Comment Resolution Status

Document: T10/1415-D revision 12

From: Cris Simpson, Intel Corporation

Subject: Response to T10 Letter Ballot comments on SRP

Figure 0.1 - IB I/O unit example

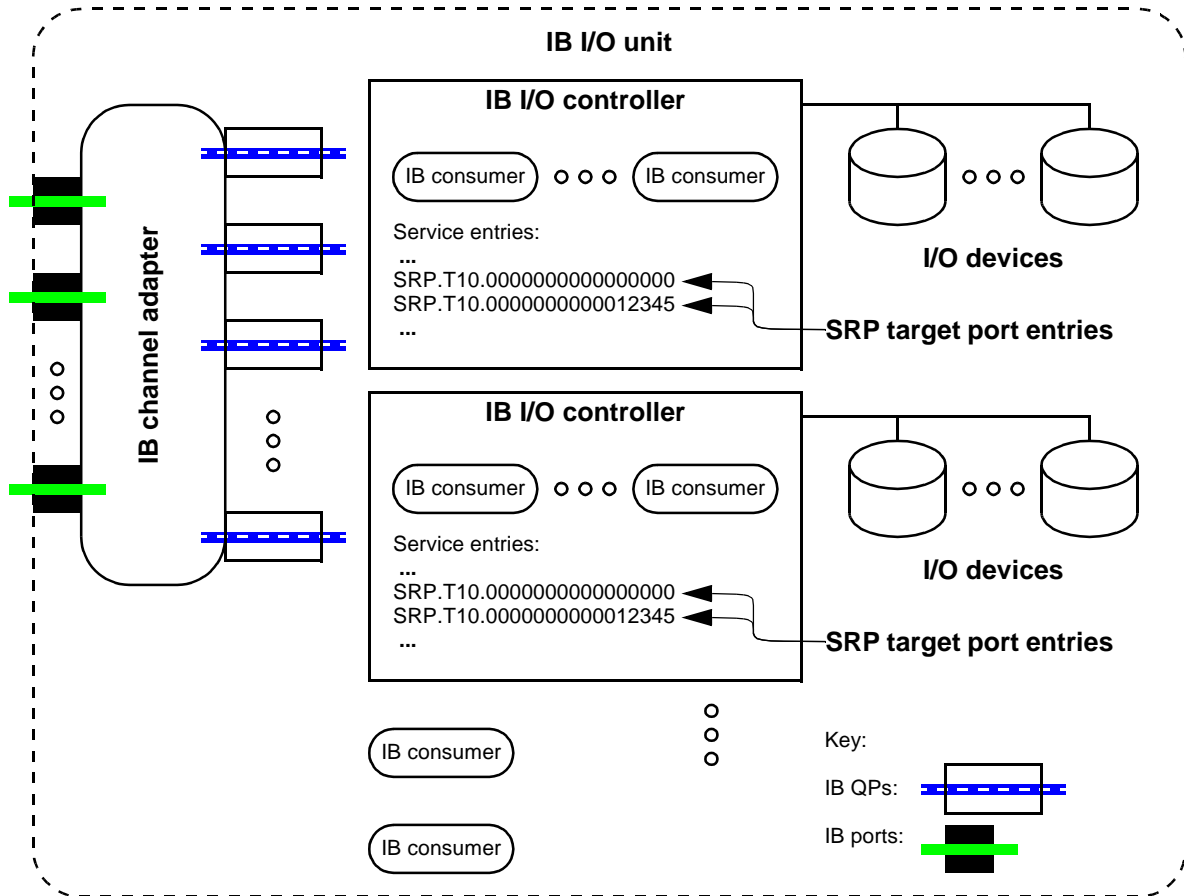
Figure B.3's equating of 'SRP Target Ports' with 'IB consumers' is problematic. A 'target port' is a sort of service access point---somewhere where interested parties initially go to obtain service, but without any implication that that's where the service is actually provided. (In IB, it's the Connection Manager that receives the initial connection request, interprets the ServiceID contained therein, and performs some magic that results in the instantiation of a QP bound to some entity that actually provides the target services). This target-services-providing entity fits the definition of 'IB consumer'. But the mapping of ServiceIDs-cum-SRP target ports onto such entities is clearly a matter of implementation, and could be one-to-many, many-to-one, or many-to-many Suggested Solution: One possibility: to the left of the IB Consumers show a table/list of service IDs within each IB I/O unit and label these entries as SRP Target Ports; use arrows to show a mapping from the entries to the IB Consumers, with e.g. one Consumer mapped to two IDs and another mapped to one ID to show that the mappings are not always 1 to 1. A further refinement might be to use another set of arrow between the Consumers and the QPs to show that the this mapping is also not 1 to 1

Notes from 28 Nov 2001 teleconference: show service entries in figures B.2 and B.3, in accompanying text explain that each service entry identifies an SRP target port.

This comment is correct, but it's not immediately obvious how to incorporate it into a legible diagram. Note the further complication introduced by connection redirection. The IB consumer (IB QP and the software, etc. behind it) may be in an unrelated device / node / whatever, it need not be the same channel adapter or even an I/O unit. The sole purpose of the I/O unit and I/O controller is to obtain a service ID, connecting to that service ID may lead somewhere else altogether.

The following is an attempt at a modified figure B.2 and the text describing service entries that identify SRP target ports

Figure 1 - SCSI document relationships

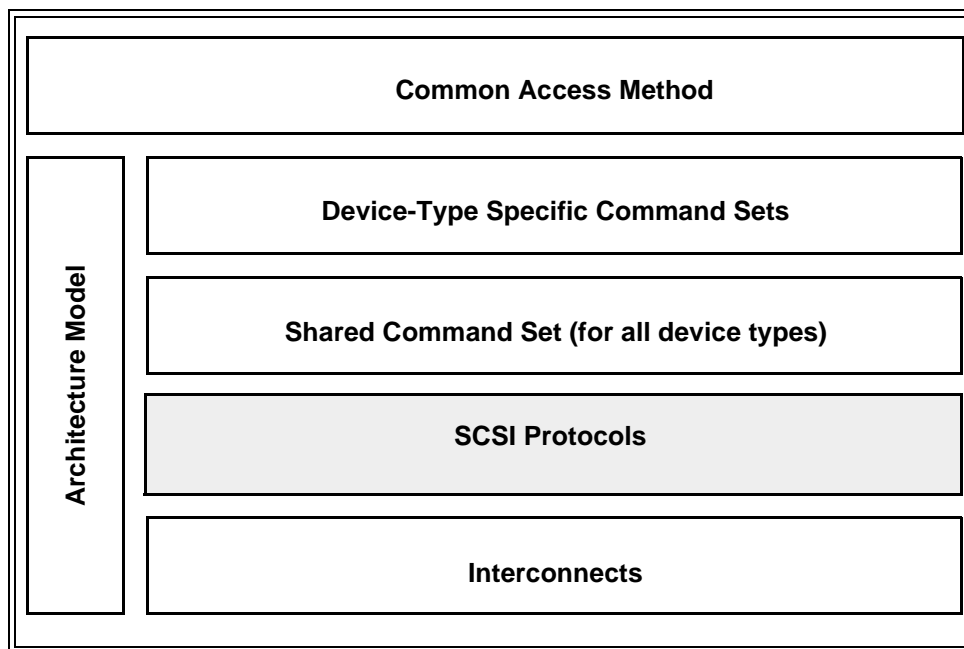
Delete CAM from figure 1 Delete these SCSI-2 standards from the example standards list:
Serial Storage Architecture SCSI-2 Protocol SSA-S2P [ANSI X3.294:1996] Common Access Method: SCSI Common Access Method CAM [ISO/IEC 9316-421] [ANSI X3.232:1996]
The 28 Nov 2001 teleconference voted that this be accepted.

"Figure 1 shows the relationship of this standard to the other standards?" But it doesn't. The SRP standard is not identified in the figure. Despite the disclaimer, layering of the blocks does suggest a hierarchy, protocol stack and system architecture. But the figure does not indicate the applicability of SRP to the implementation of a SCSI transport, as far as I can tell.

Figure 3 - Example RDMA channel establishment

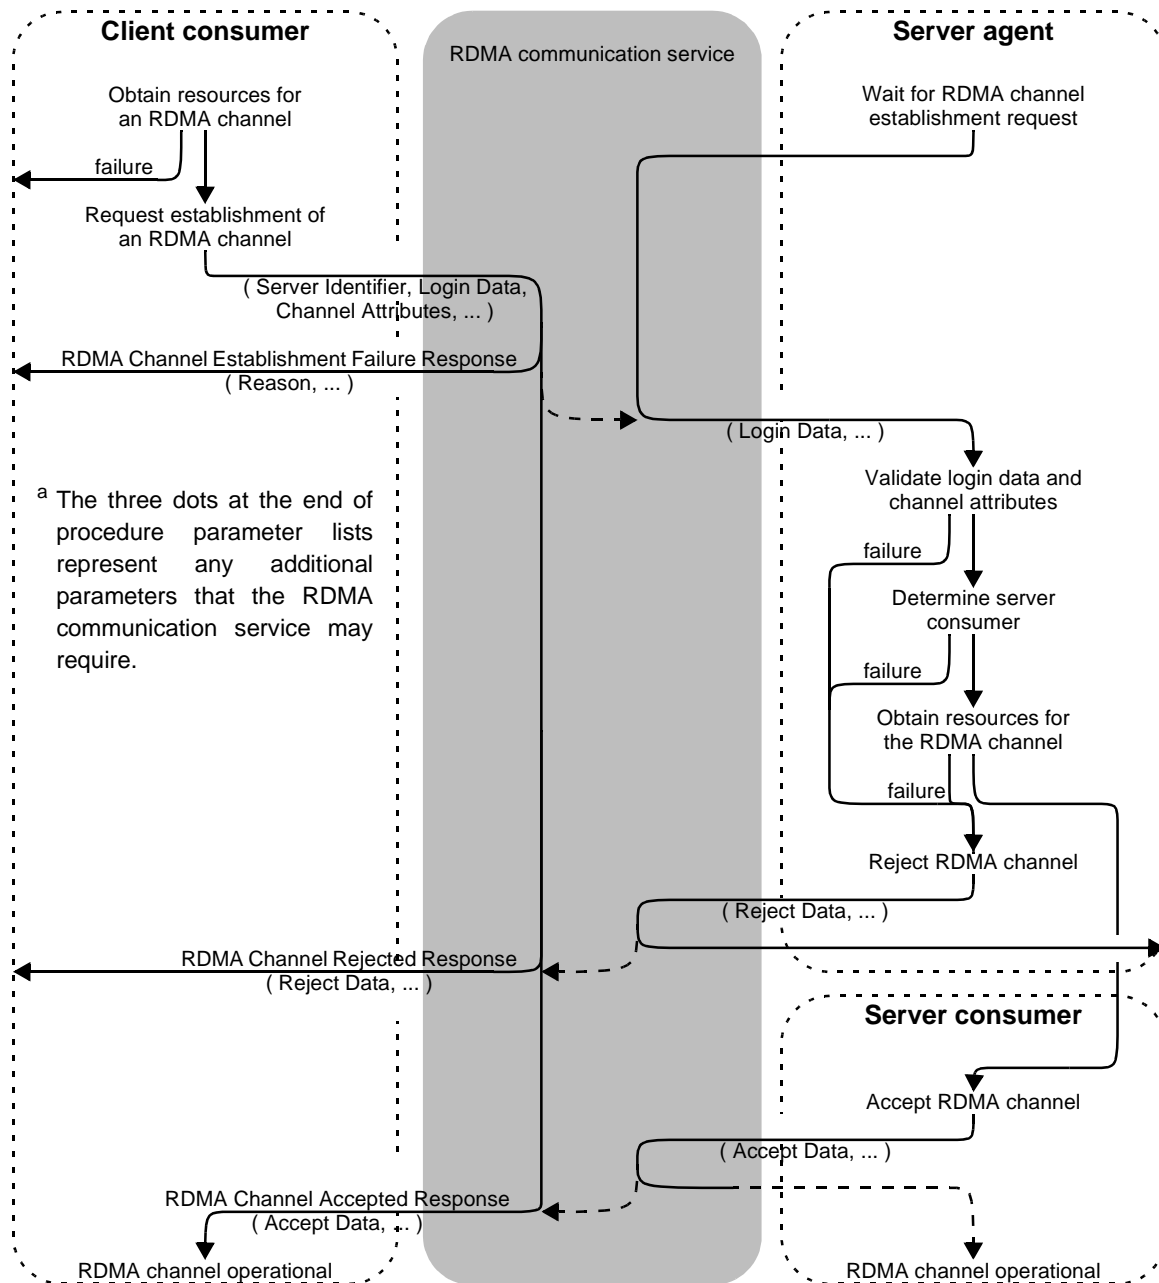
- IBM024 PDF Page 21** **Open**
Page 9 - Figure 3 - line 40 - The arrow exiting to the right seems to dead end. Where does the flow go from there. All the other exit points are clear that one is not.

Figure 4 - Memory descriptor mapping

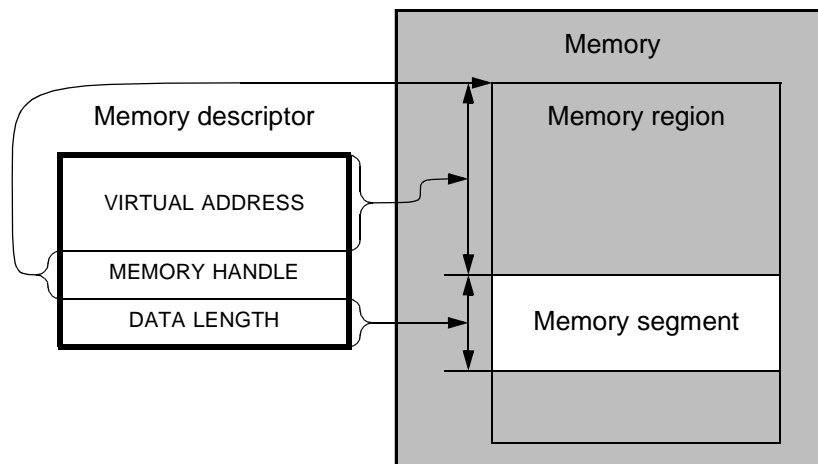
Page 17 - Figure 4 - The way the arrows are pointing for the virtual address implies that it is not the address of the first byte of the memory segment. It currently implies that it is the space from the memory handle to the beginning of the memory segment which is the memory region. It is also not clear as to what the boundaries are of the memory region. The current drawing implies it is only the area above the memory segment. I do not believe that is correct so it needs to be fixed.

Figure A.2 - Model for a four step confirmed service

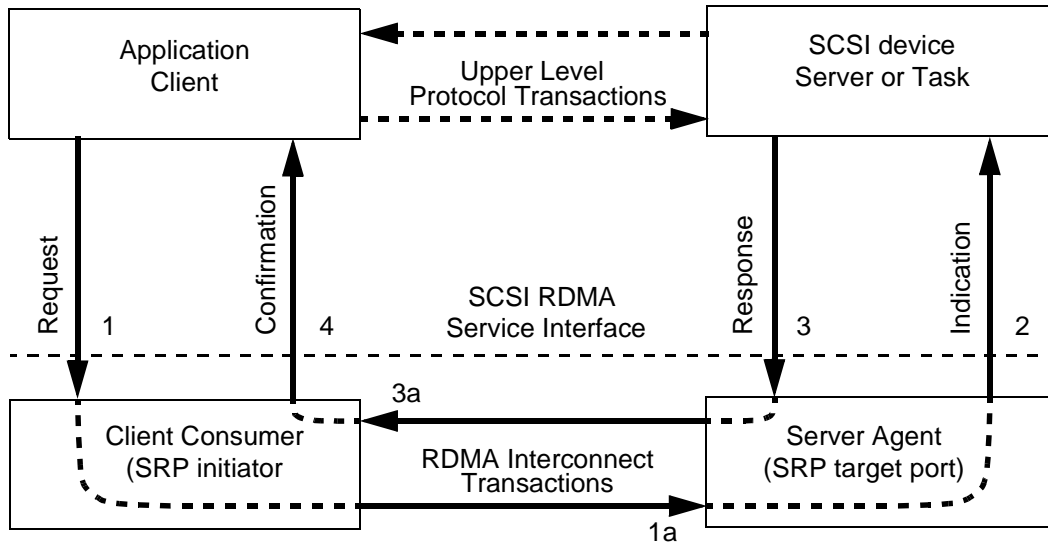
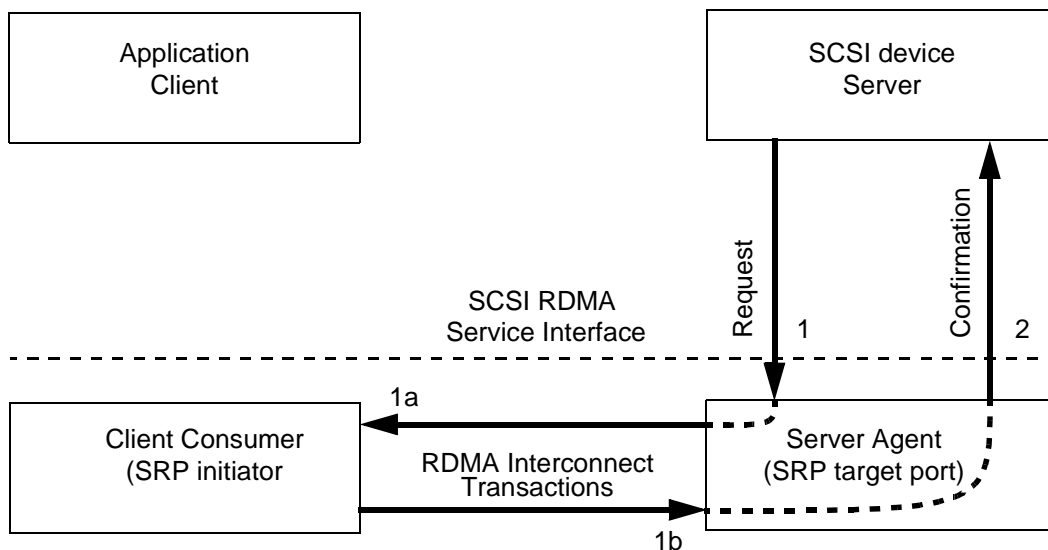
- | IBM0129 PDF Page 58** **Open**
Page 46 - figure A.2 and A.3 - line 15 and 43 - The statement '(SRP initiator' should be '(SRP initiator port)'

Figure B.2 - IB I/O unit example

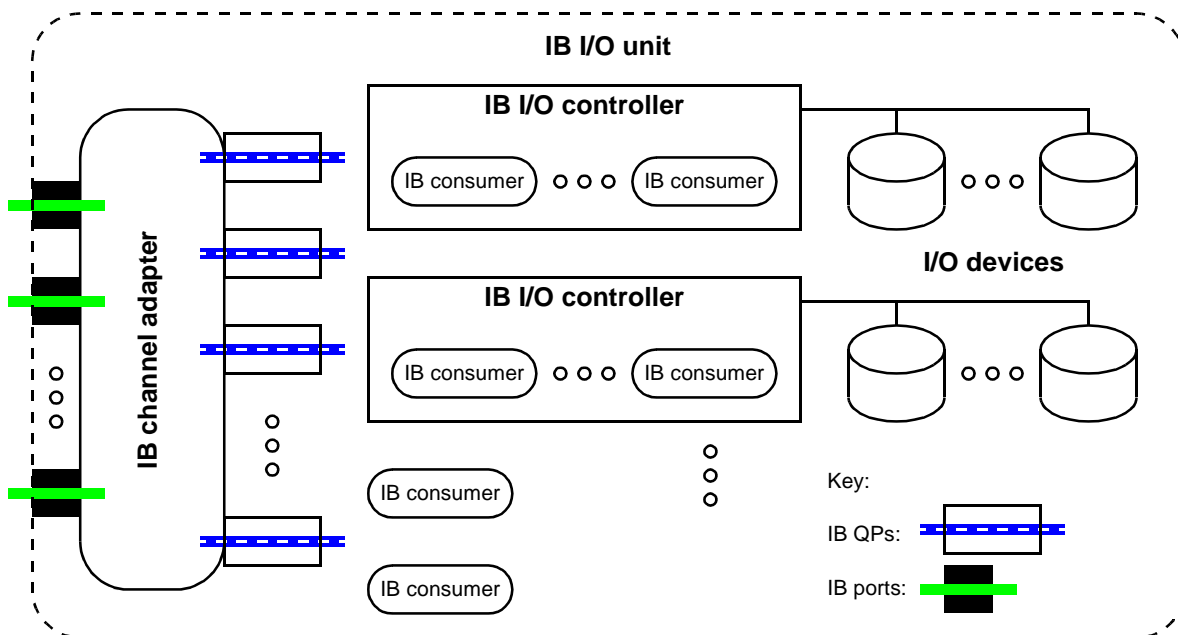
Figure B.2. Can I/O controllers be virtual objects?

Figure B.2. What is the purpose of allowing multiple IB consumers per IB I/O controller? Is it so that multiple IB connections can be terminated within an IB I/O controller? (This relates to the question above about correspondence between QPs and IB consumers.)

Figure B.2. How are shared LUs modeled? Do SRP target ports contain the "task router" function described recently by Penokie? Can two IB I/O controllers have an underlying LU in common, or is this functionality restricted to two IB consumers within the same IB I/O controller?

Figure B.3 - SCSI architecture mapping

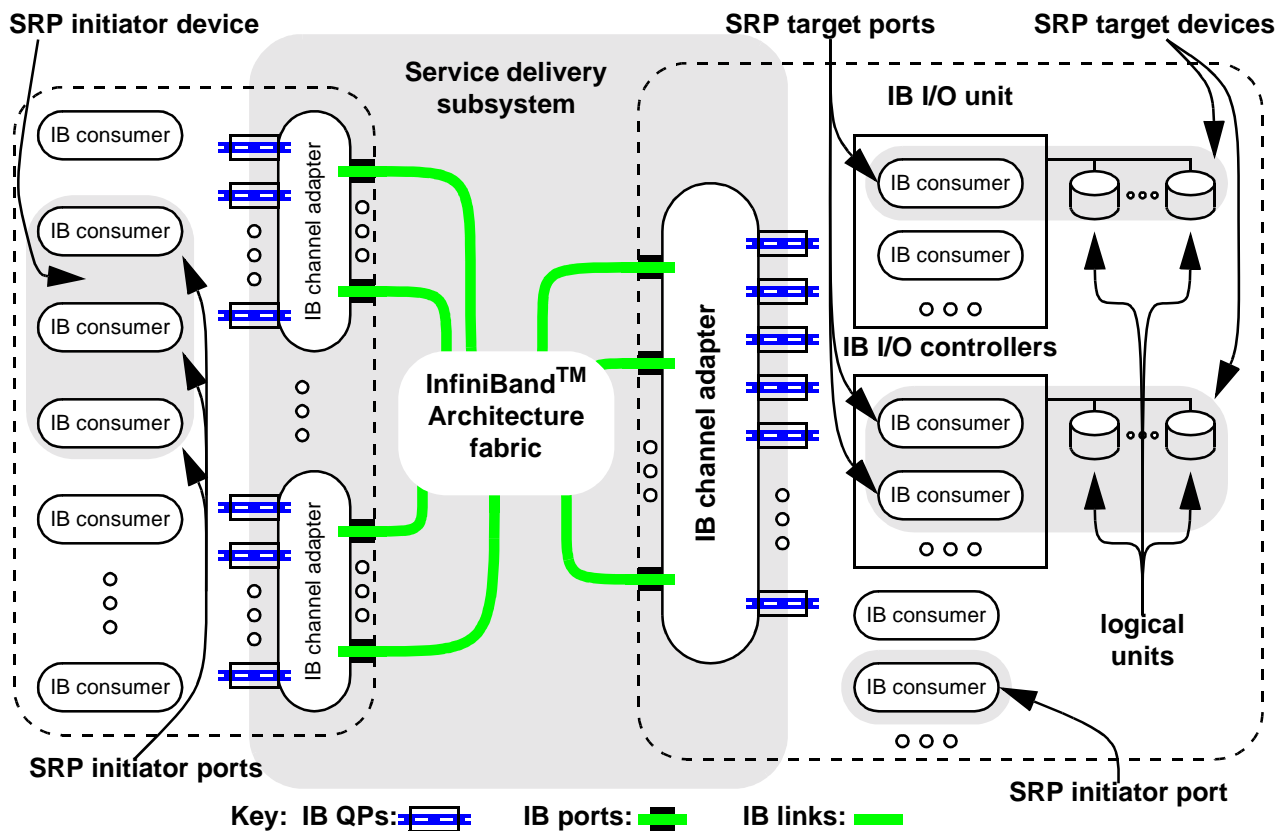
Figure B.3. What is the object indicated by the dashed lines in the initiator model, analogous to the IB I/O unit in the target model?

Figure B.3. and 56-1. Table B.2. The rules for constructing initiator ports seem entirely too lax. The text says, "Initiator port identifier should be constructed?" And then the Table indicates that GUID, for example, is the channel adapter GUID. Is there no meaning associated with the initiator port ID? Is the only design goal that the 16B port ID be globally unique? Will any GUID do at all? If so, let's be explicit about this, and **let's not make any suggestions about the origin (and possible meaning) of the port name.**

Feb15: Add a SRP-general description to Clause 5. In Anx B, Shall be a GUID (EUI?), should be a CA GUID + extension.
